CITY OF FRESNO - ADDENDUM NO. 1

CONSTRUCTION OF NORTH AVENUE STREET IMPROVEMENTS, STATE ROUTE 41 TO STATE ROUTE 99 (Fed. No. STPL 5060-061)

BID FILE NO. 2488-10205

NOTICE TO ALL BIDDERS

(MODIFICATIONS TO NORTH AVENUE PLAN AND PROFILE SHEET NO. 10)

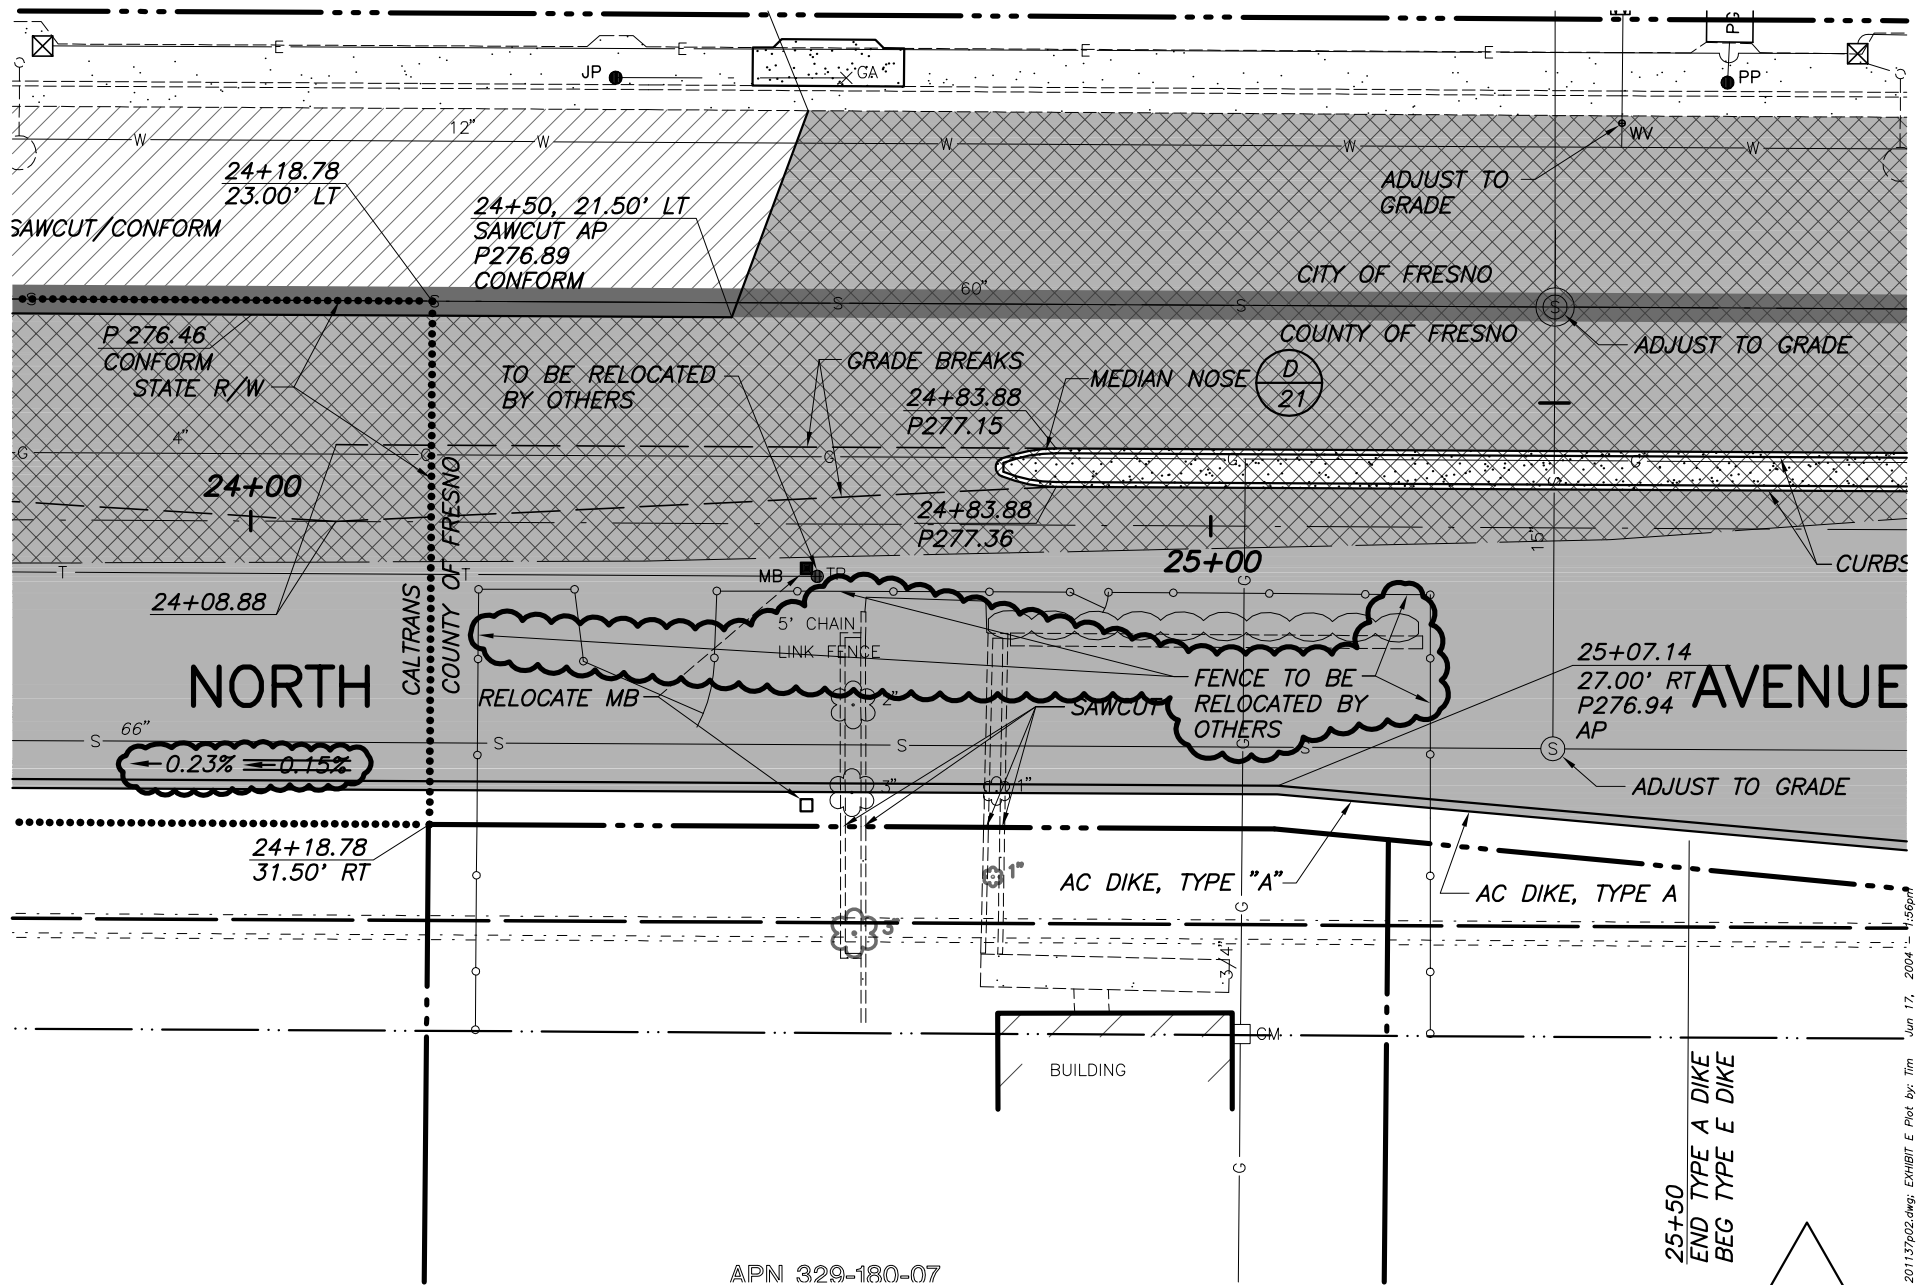
13. Add: Exhibit 1A, Addendum No. 1 (Typical Section modification)
14. Add: Exhibit 1B, Addendum No. 1 (Street Plan modification)
15. Add: Exhibit 1C, Addendum No. 1 (Street Plan modification)

16. Add: Exhibit 1D, Addendum No. 1 (Street Plan Modification)
17. Street Plan Sheet 21, Detail F/21: Reference to "12" RCP" shall be changed to "**12" PVC PIPE**".
